# Wisconsin Department of Transportation

**Proposal #6: 5992-08-85, WISC 2015 635  
Lower Yahara River Trail Phase One  
Capital City Trail to McDaniel Park  
Non Highway  
Dane County**

This is Addendum No. 03, which provides for the following:

Addendum No. 03  
ID 5992-08-85  
Revised Sheet 6  
December 4, 2015

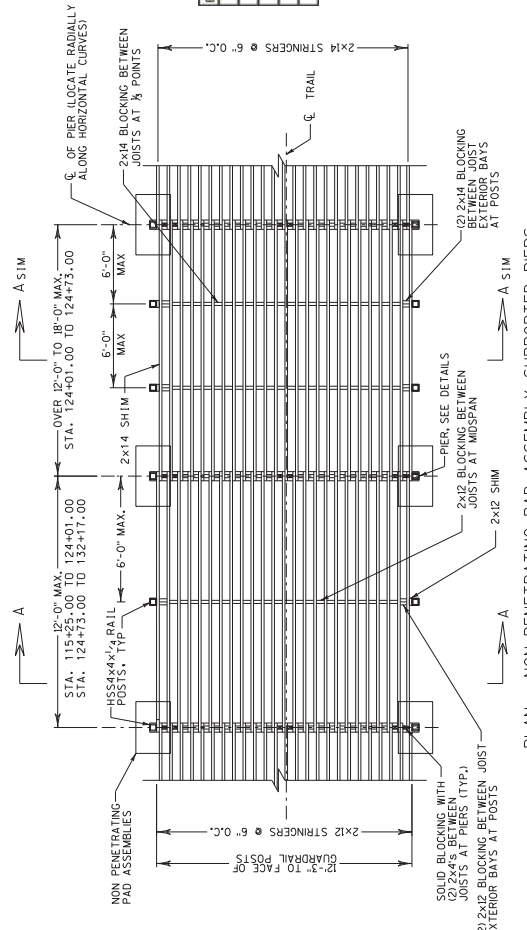
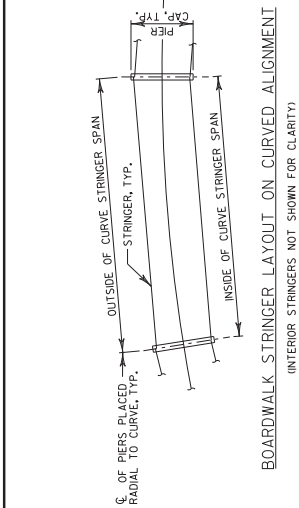
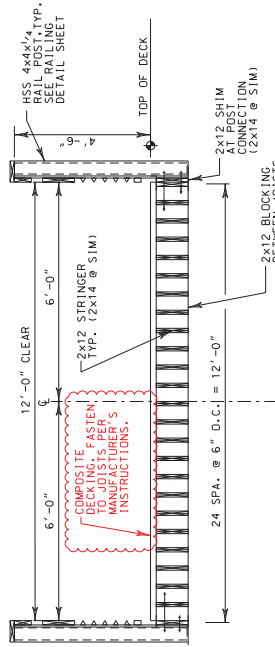
Revised Plan Sheets	
Plan Sheet	Plan Sheet Title (brief description of changes to sheet)
6	Construction Details – Modified composite decking call out and notes.
7	Construction Details – Modified composite decking call out and notes.
90	Structure B-13-811, Cross Sections, General Notes and Quantities – Modified general notes for composite decking.
94	Structure B-13-811, Abutment Details and Bill of Bars - Modified composite decking dimension call out.
102	Structure B-13-834, Cross Sections, General Notes and Quantities – Modified general notes for composite decking.
105	Structure B-13-834, Abutment General - Modified composite decking dimension call out.
107	Structure B-13-834, Truss Details – Removed composite decking note.

NOTE REMOVED

REVISION	BY
GENERAL NOTE REVISION	ACW
STATE OF WISCONSIN	DEPARTMENT OF TRANSPORTATION
STRUCTURE B-13-811	
DRAWN BY	PLANS CDR. JML
CROSS SECTION, GENERAL NOTES AND QUANTITIES	SHEET 2 OF 12
90

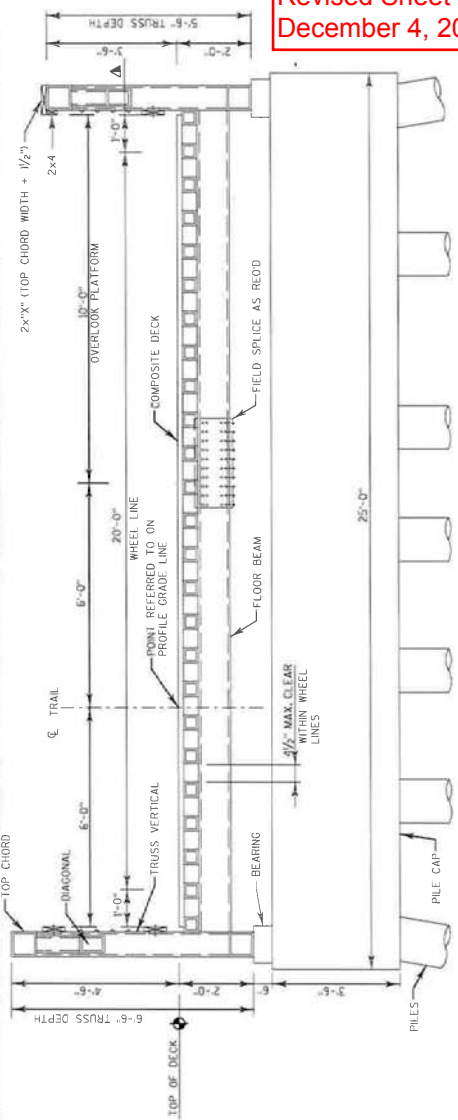
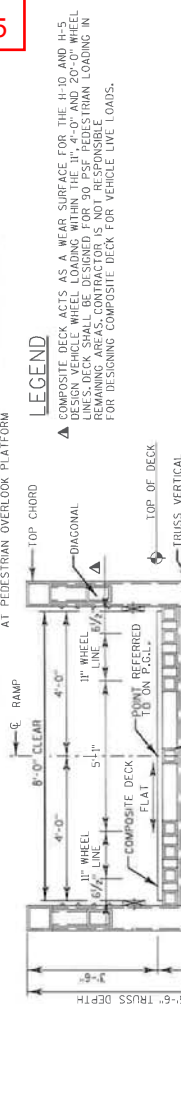
SEE SPECIAL PROVISIONS FOR COMPOSITE DECK, 4 1/2" MAX CLEAR WITHIN WHEEL LINES AND 15'-0" CLEAR OVER THE COMPOSITE DECK. INCREASE CLEAR AND APPLY FOR CONSISTENCY WITH WETLAND BOARDWALK DESIGN.

ABUTMENT DETAILS AND BILL OF BARS  
SHEET 6 OF 12  
94

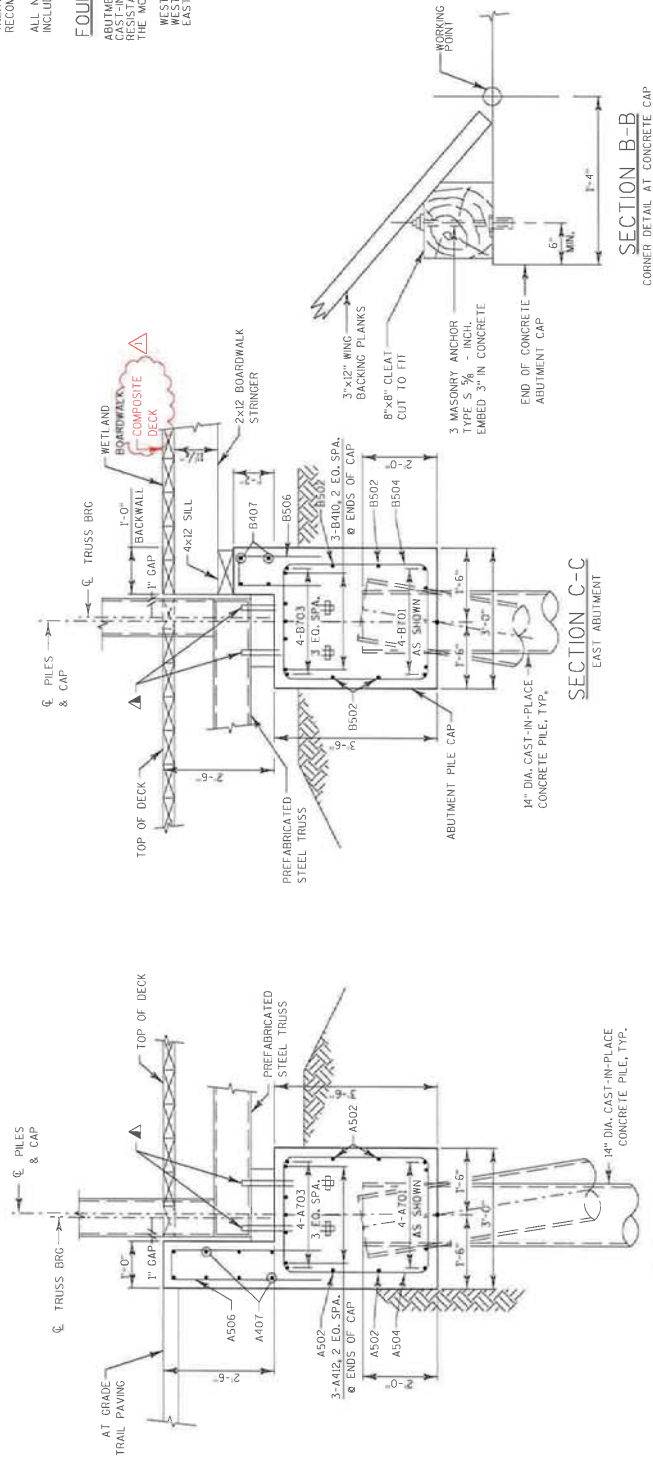
NO.	DATE	REVISION	BY
1		COMPOSITE DECK NOTE REVISION	KGM

SHEET 2 OF 7  
 102

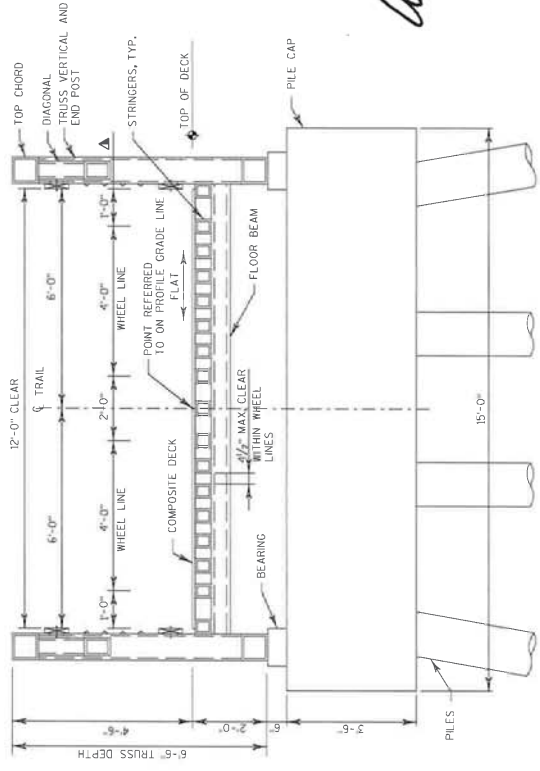
NO.	DATE	REVISION	BY
1		COMPOSITE DECK NOTE REVISION	RCR

SEE SPECIAL PROVISIONS FOR COMPOSITE DECK THICKNESS, GENERAL CONTRACTOR AND TRUSS MANUFACTURER TO COORDINATE COMPOSITE DECK THICKNESS, COLOR AND SUPPLIER FOR CONSISTENCY WITH METLAND BOARDWALK DECKING.

**LEGEND**  
 ▲ COMPOSITE DECK ACTS AS A WEAR SURFACE FOR THE H-10 DESIGN VEHICLE WHEEL LOADING WITHIN THE 4'-0" WHEEL LINES. DECK SHALL BE DESIGNED FOR 150 PSF PEDESTRIAN LOADING IN REMAINING AREAS. CONTRACTOR SHALL BE RESPONSIBLE FOR DESIGNING COMPOSITE DECK FOR VEHICLE LIVE LOADS.

ABUTMENT GENERAL  
 SHEET 5 OF 7  
 105

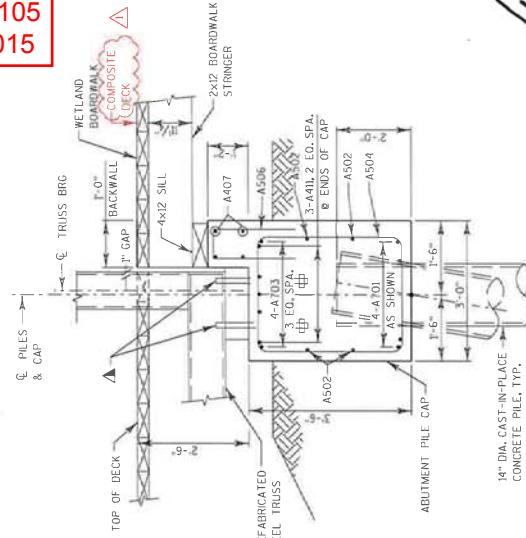
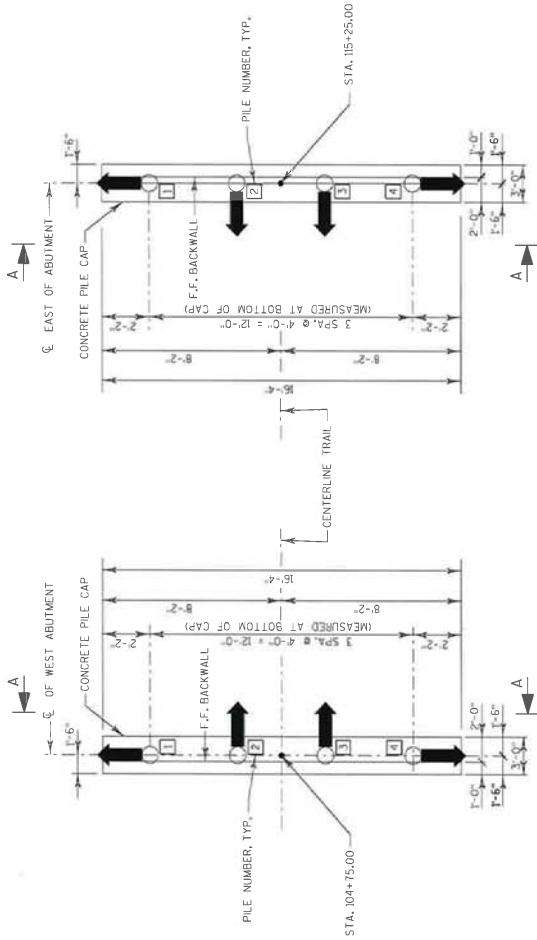
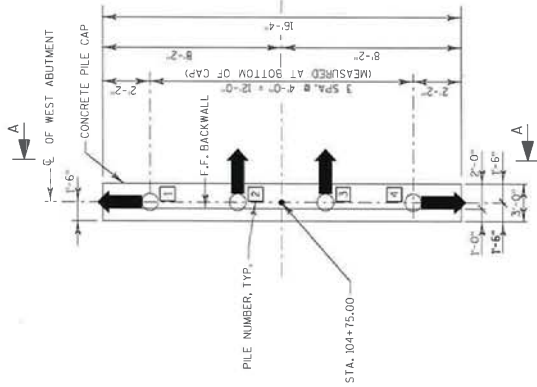
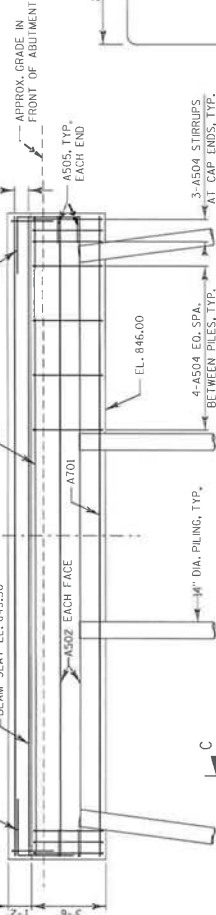
NO.	DATE	REVISION	BY
1		COMPOSITE DECK NOTE REVISION	KCP

NO.	DATE	REVISION	BY
1		COMPOSITE DECK NOTE REVISION	KGR
STATE OF WISCONSIN DEPARTMENT OF TRANSPORTATION			
STRUCTURE B-13-834			
DRAWN BY	CHKD.	AML	
TRUSS DETAILS			107

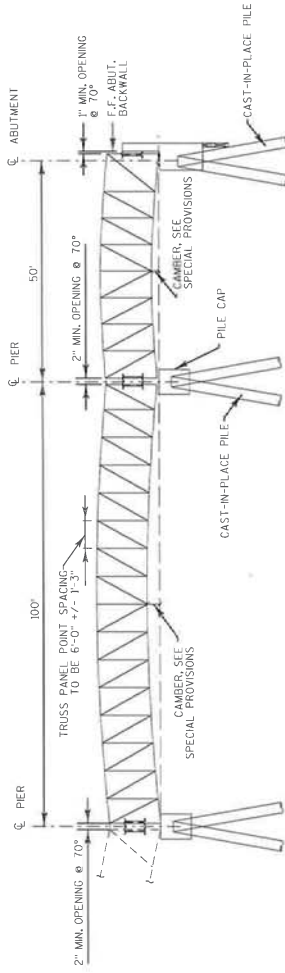
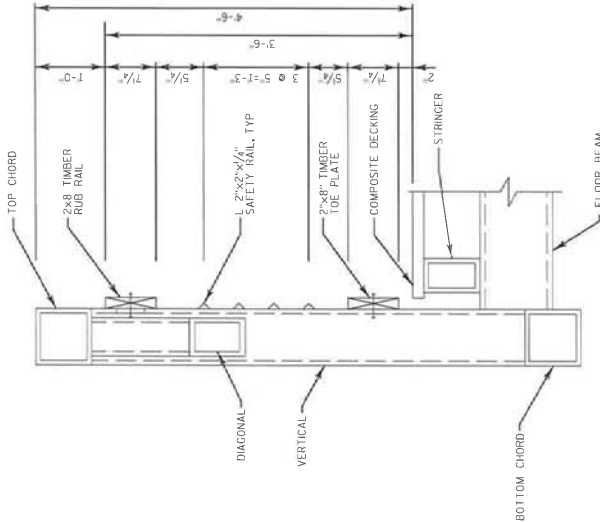
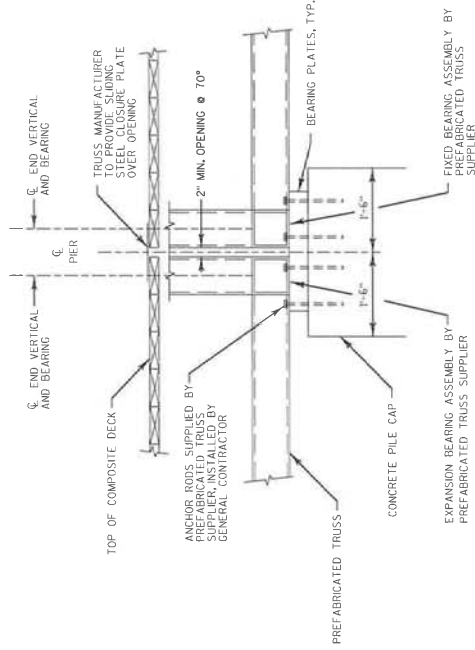
NOTE REMOVED
